FINAL ISTT DESIGN

ADDENDUM

IN-SITU THERMAL TREATMENT
FRONTIER FERTILIZER NPL SITE
Davis, CA
Submittal #0012
Final RAMP
Specification 01400, Paragraph 1.5

FINAL DESIGN REPORT
ADDENDUM
IN-SITU THERMAL TREATMENT
FRONTIER FERTILIZER NPL SITE
Davis, CA

Figure# 9B

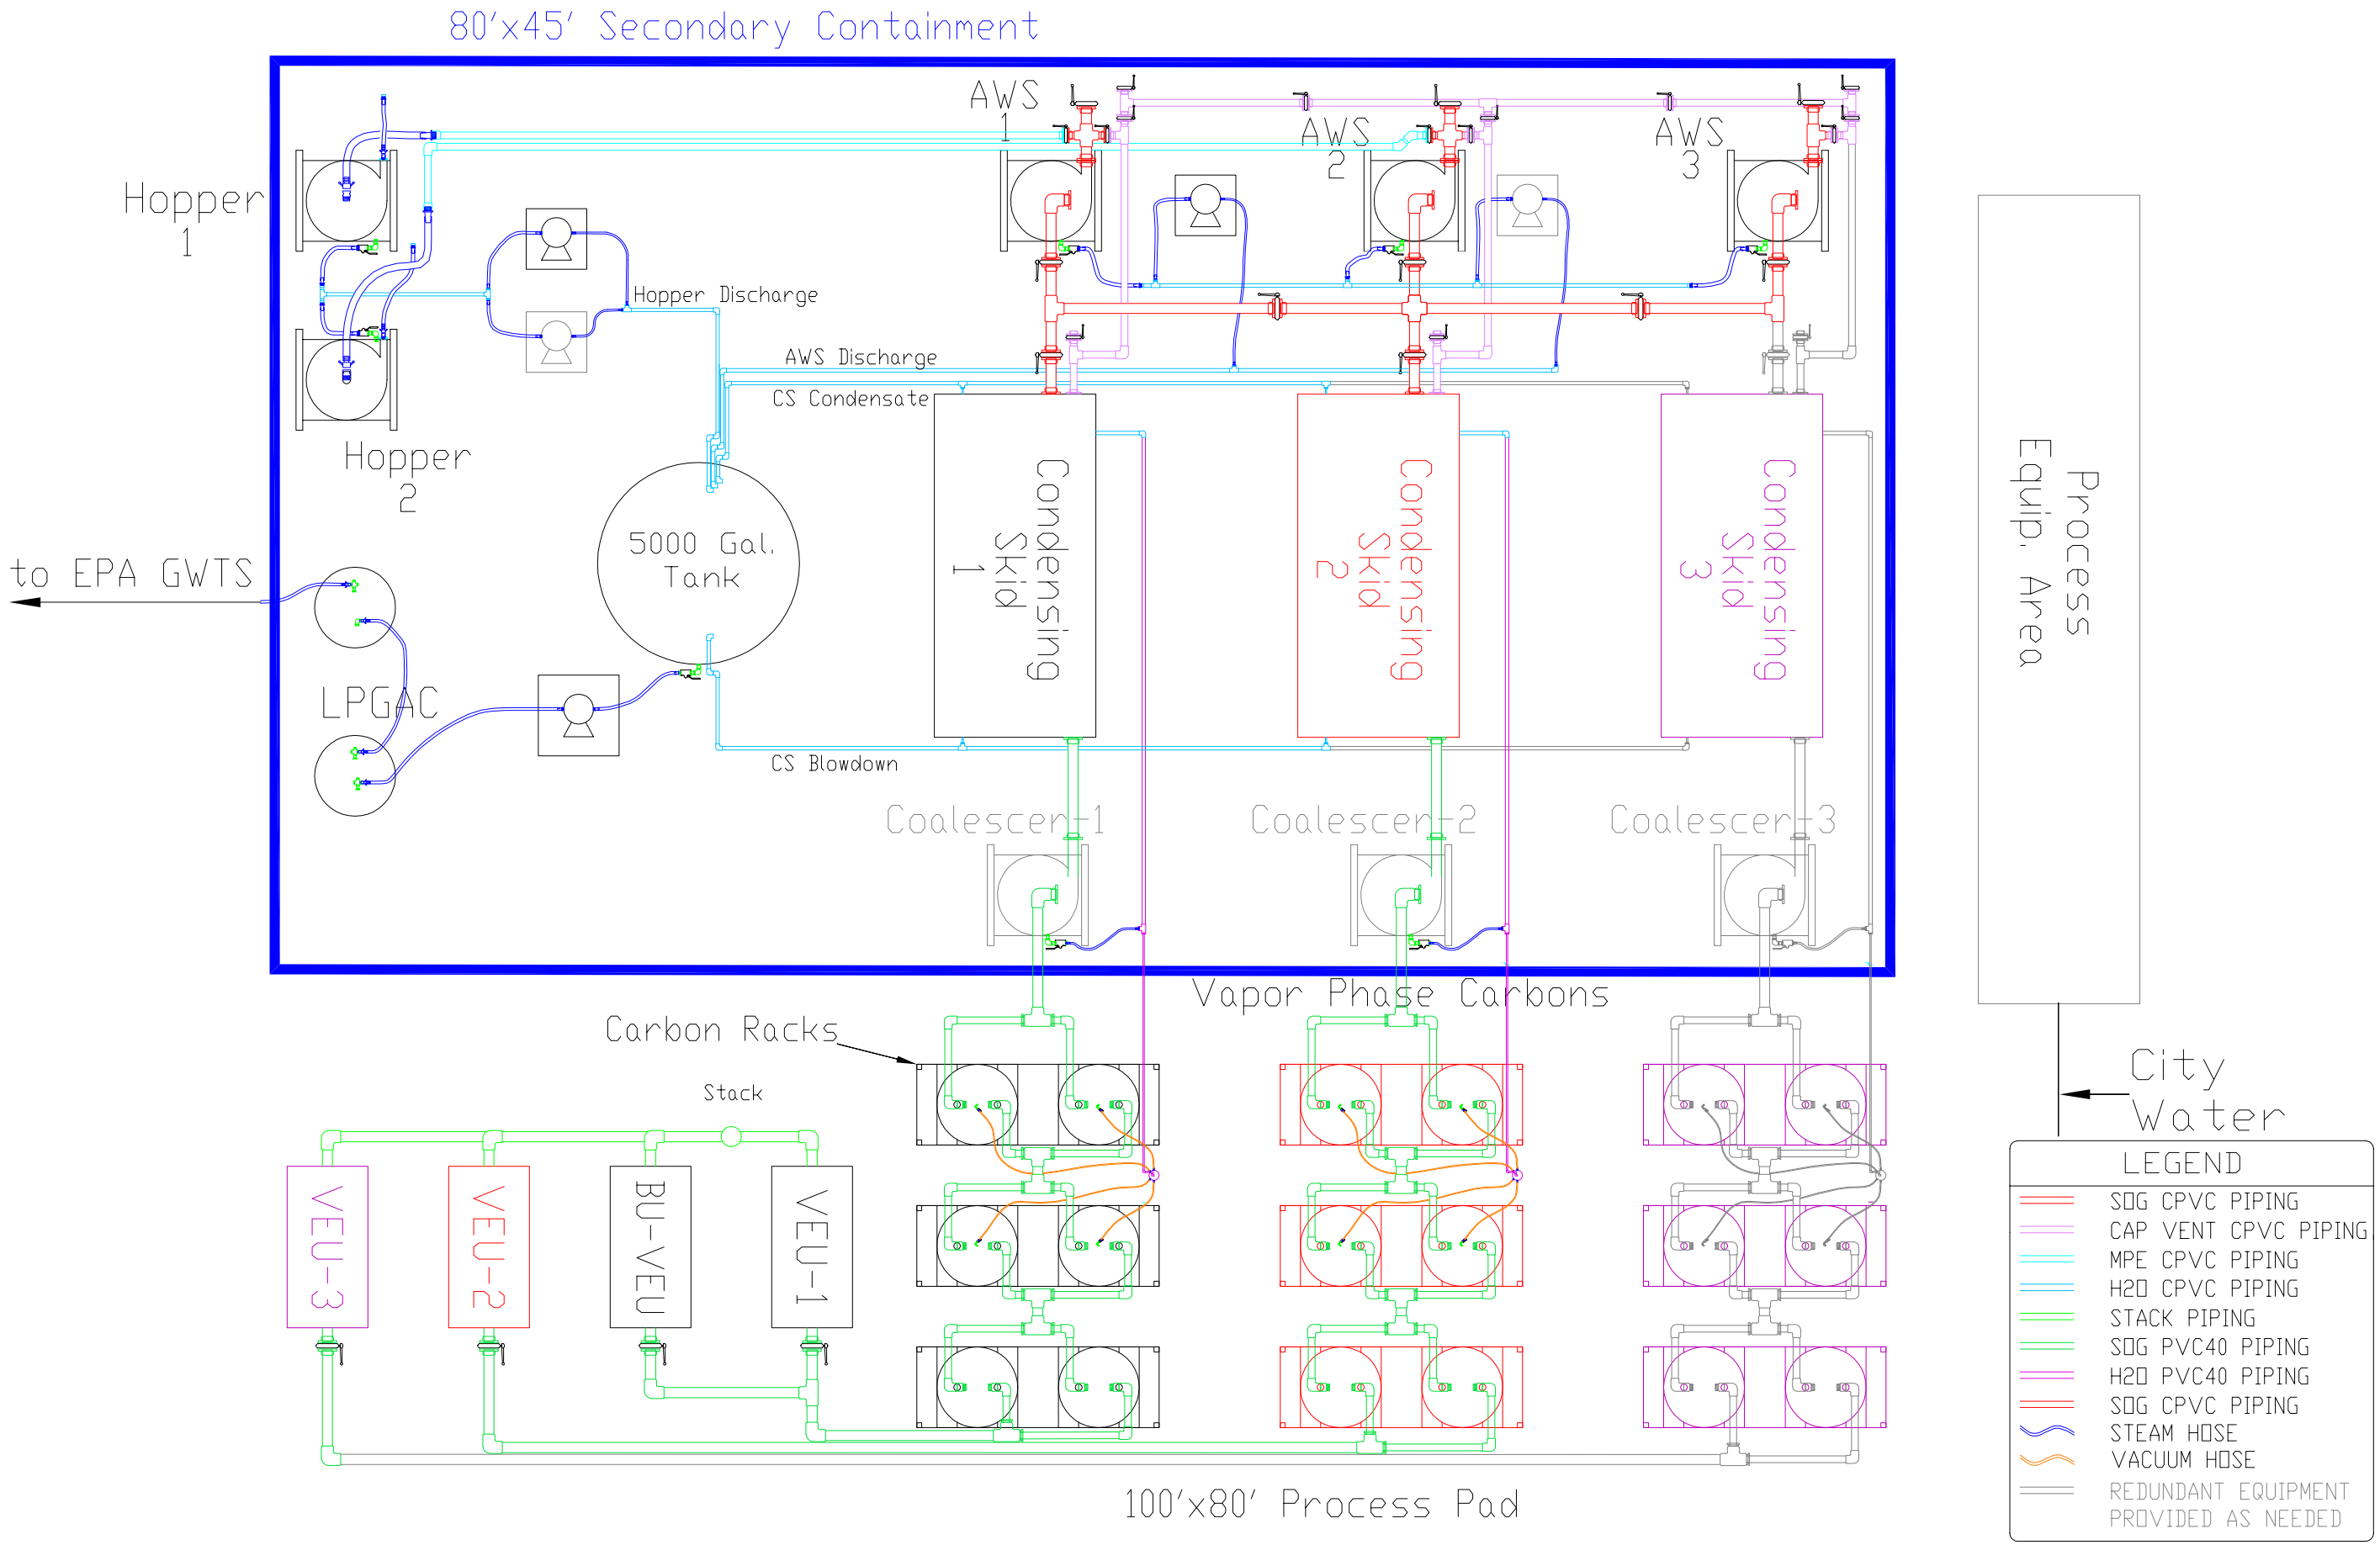
These components collectively comprise the ISTT system and are shown on a process and instrumentation diagram (P&ID) in Figure 9. Note that Figure 9 shows the process flow for the anticipated two ERH equipment setup systems, while Figure 9B shows the layout of the equipment, including the potential backup setups where appropriate.

Figure# 10

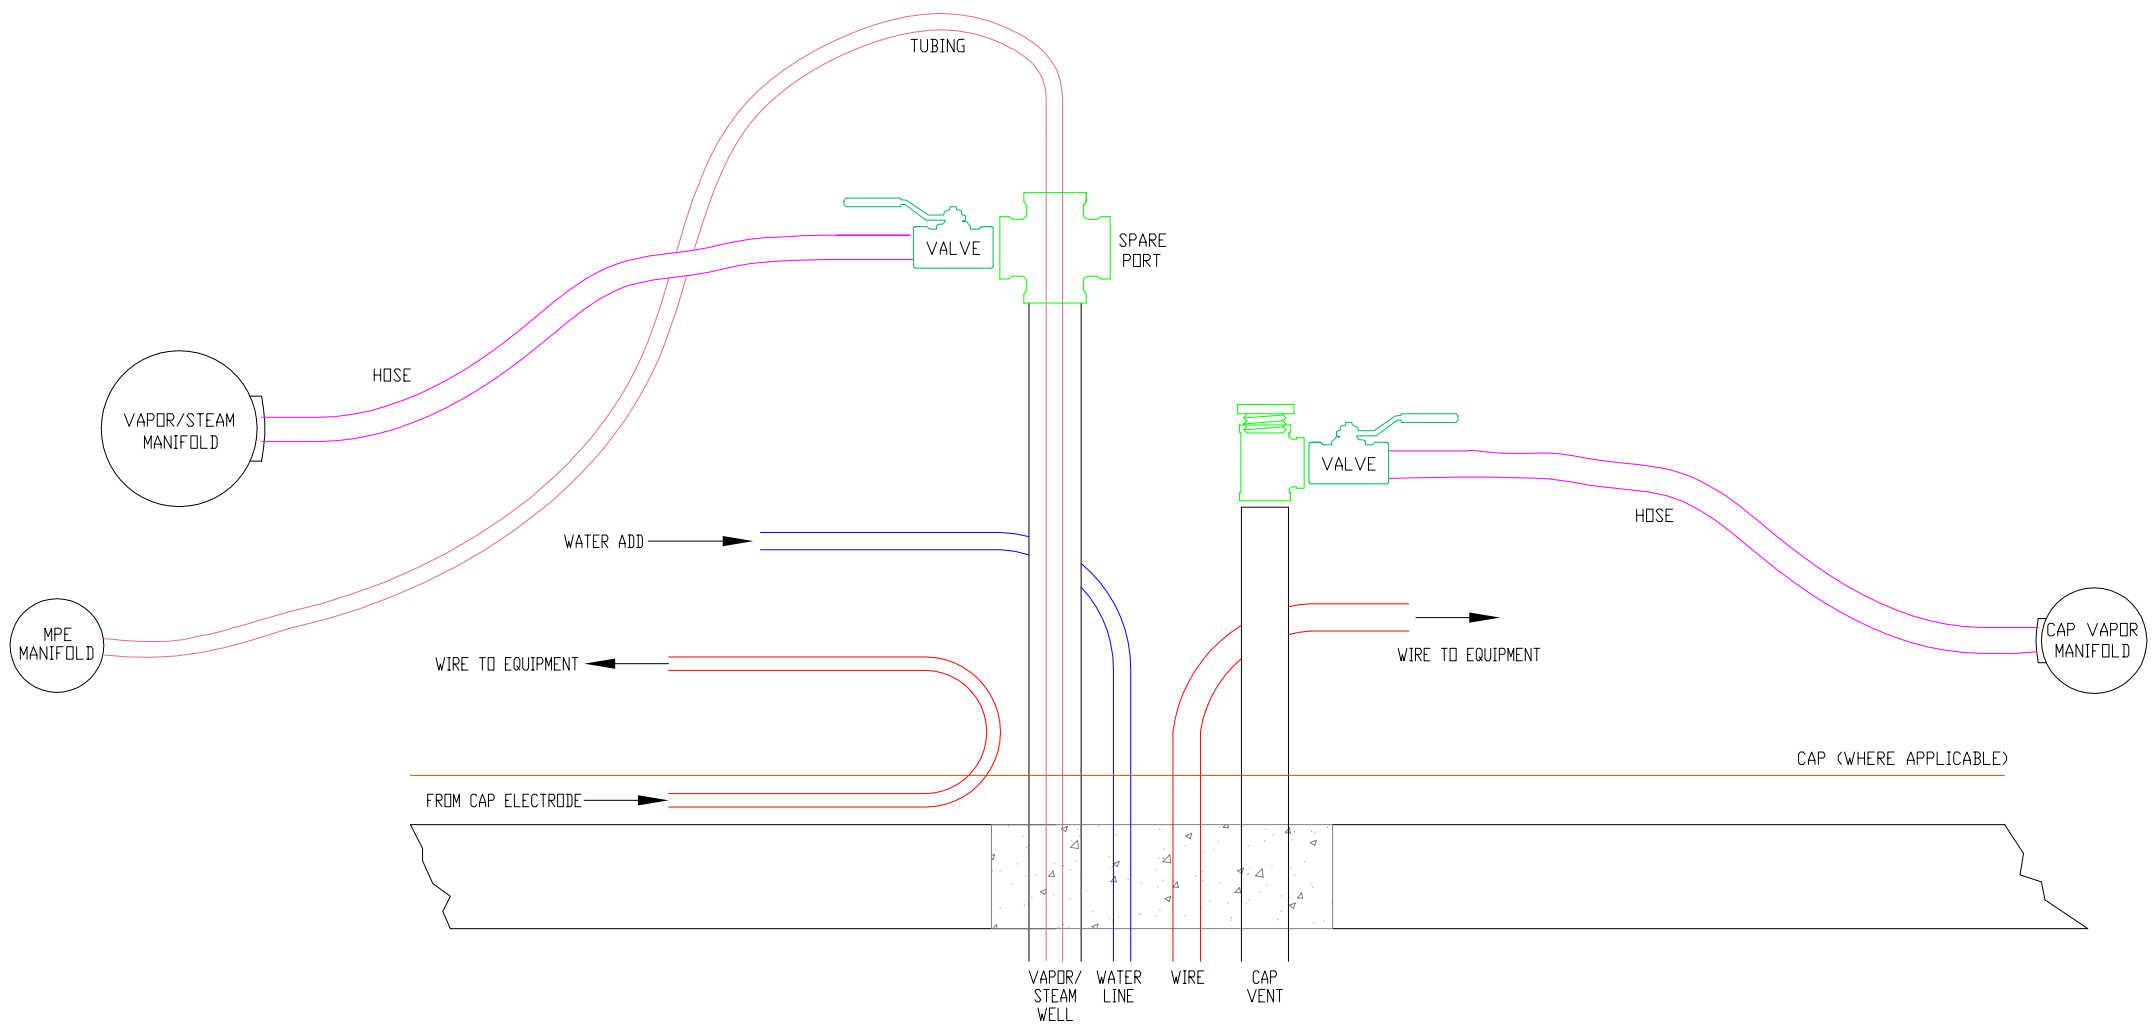
There are two distinct vapor/steam capture mechanisms employed at this site. The primary vapor/steam capture system includes the SVE and DVE wells at each electrode. The secondary system is the site cap venting system. Since each well is planned for vapor and steam extraction under vacuum, the extraction wells which are co-located with the electrodes are connected to the central VEU via manifolds at each electrode wellhead. Each wellhead includes an SVE or DVE well, shallow vent pipe and electrodes with wetting tubes. Figure 10 shows the construction details of the SVE and DVE wellheads.

Figure# 11A

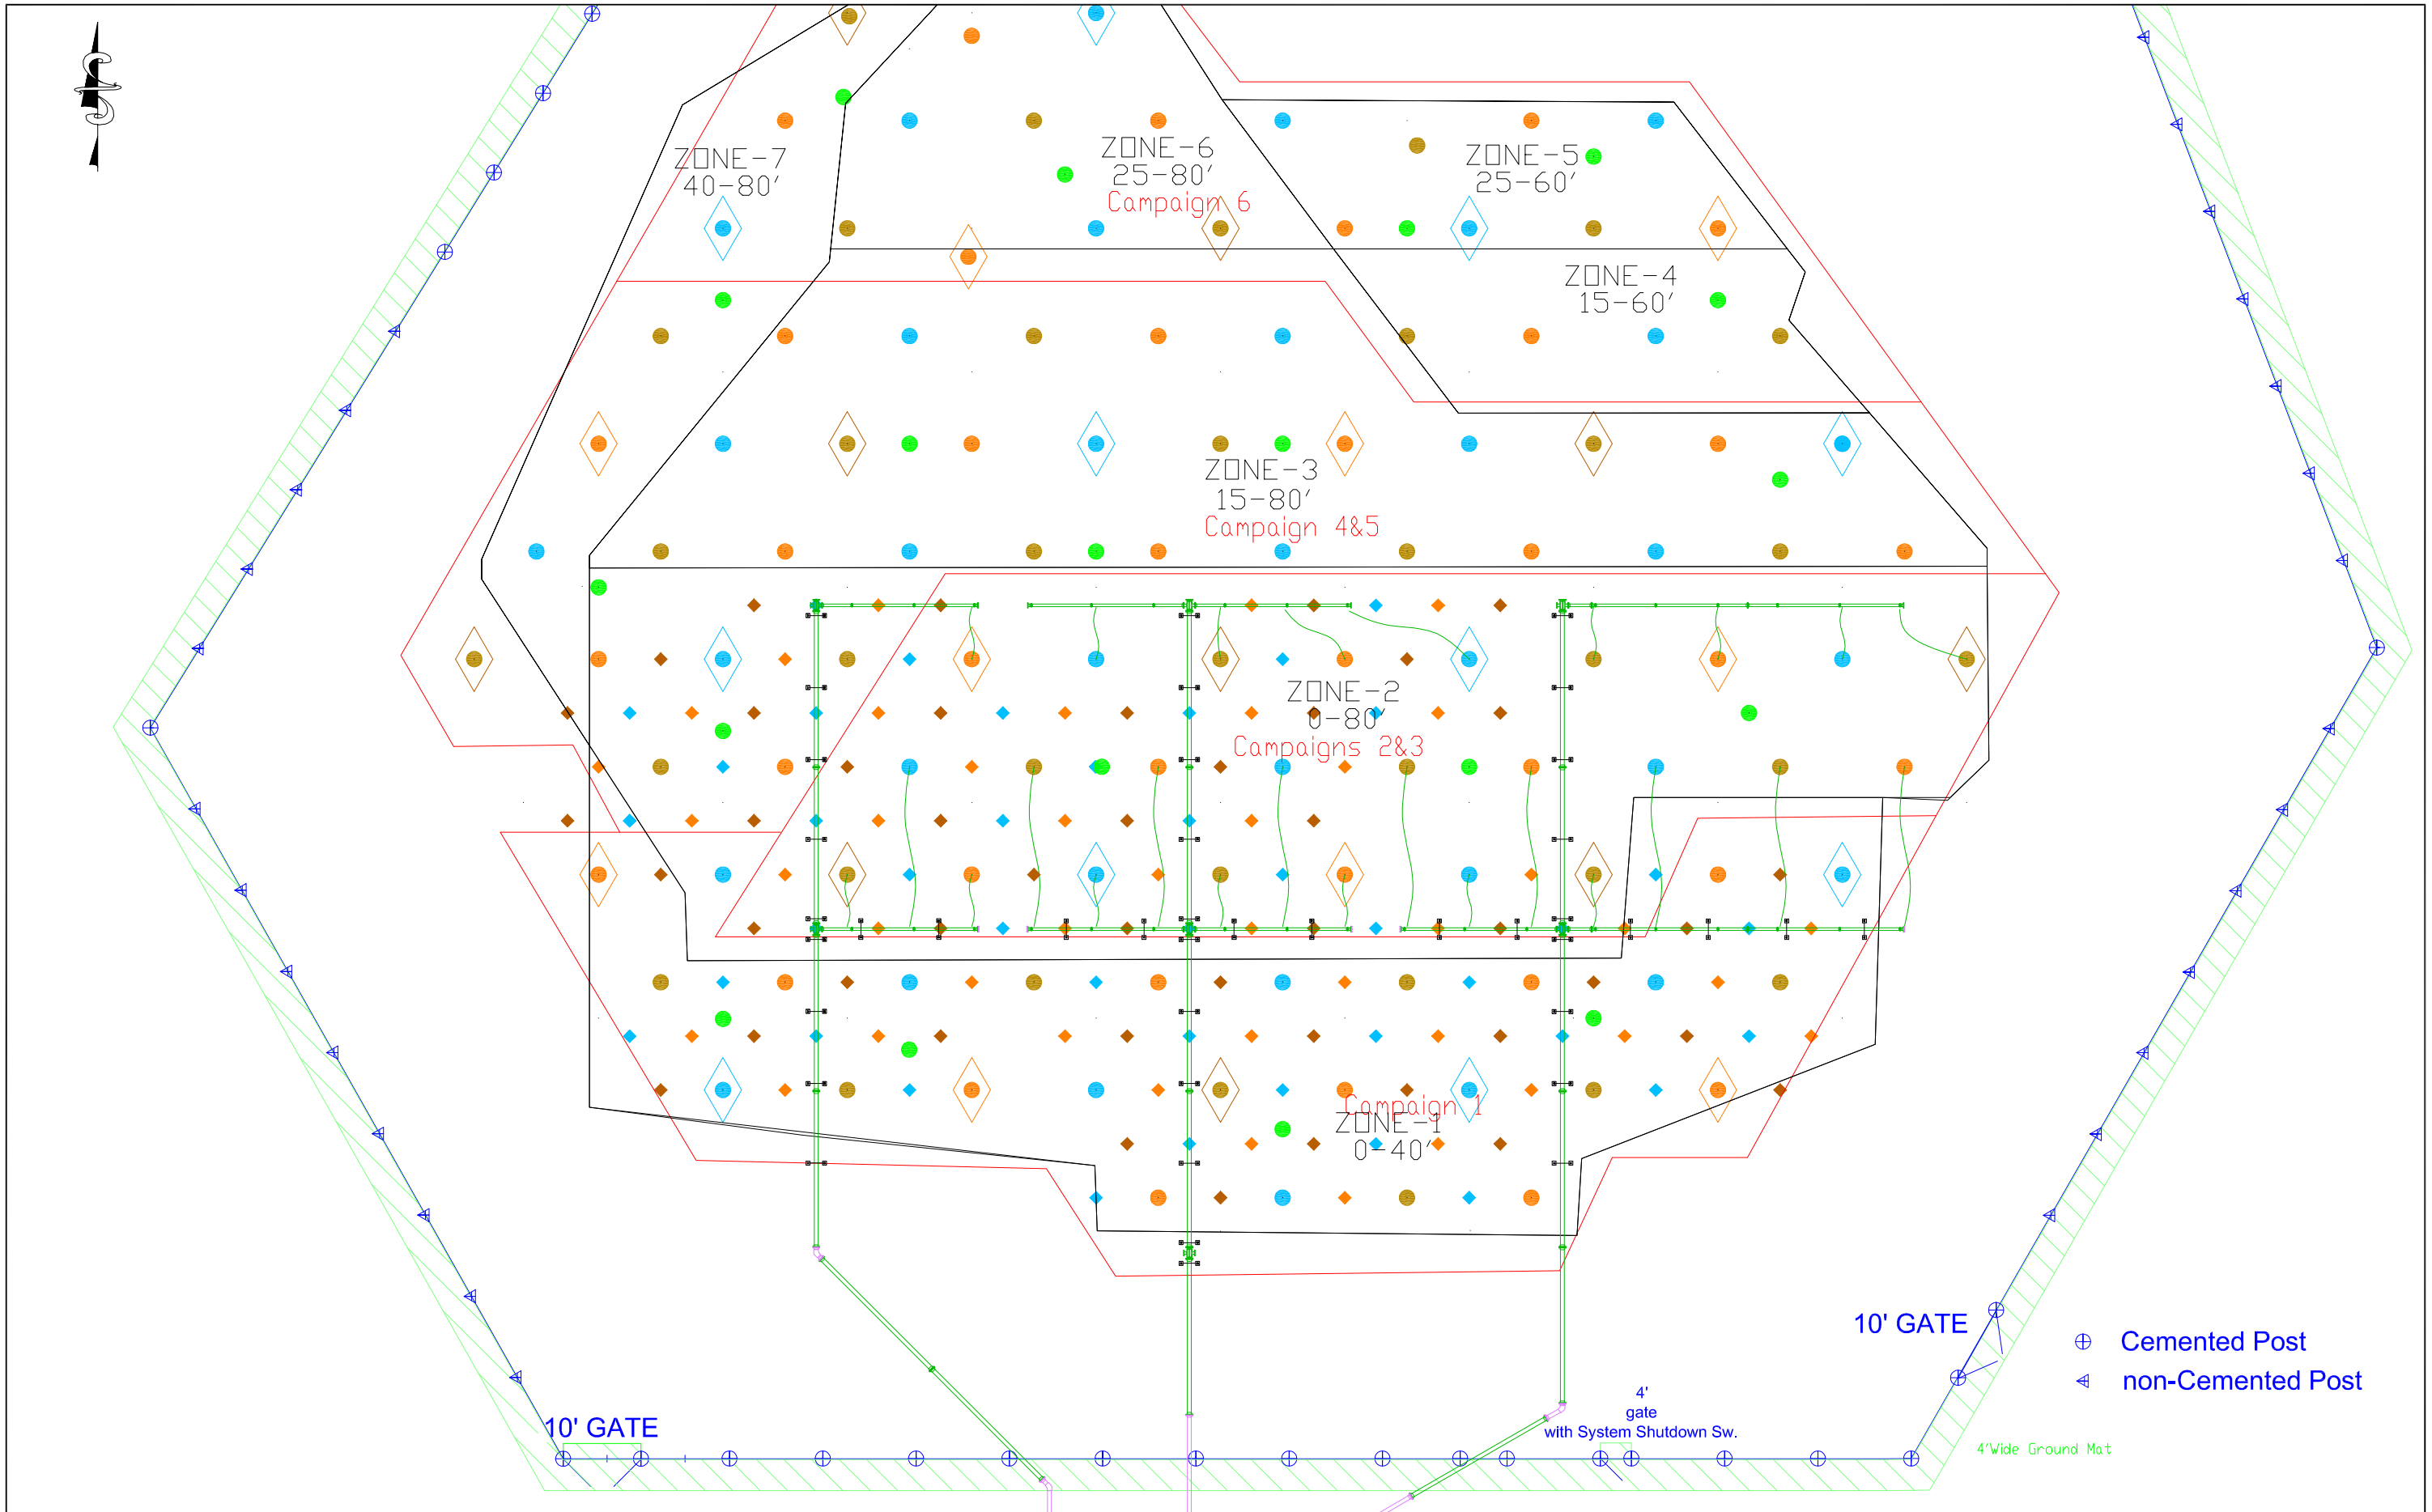
The manifolds are sized to handle the maximum expected flow per well, with about 50% additional capacity built into the piping system, at a target velocity of about 30 ft/second. Figures 11A, B and C show the layout of the piping manifold from each electrode to the process equipment area for Stages 1, 2 and 3, respectively. As more electrode wells are connected to the manifold, the size of the manifold increases to handle the additional combined flow. The manifold is designed to handle flow of vapors, water and steam simultaneously, with flexible wellhead connections, short runs and open supports to accommodate thermal expansion.
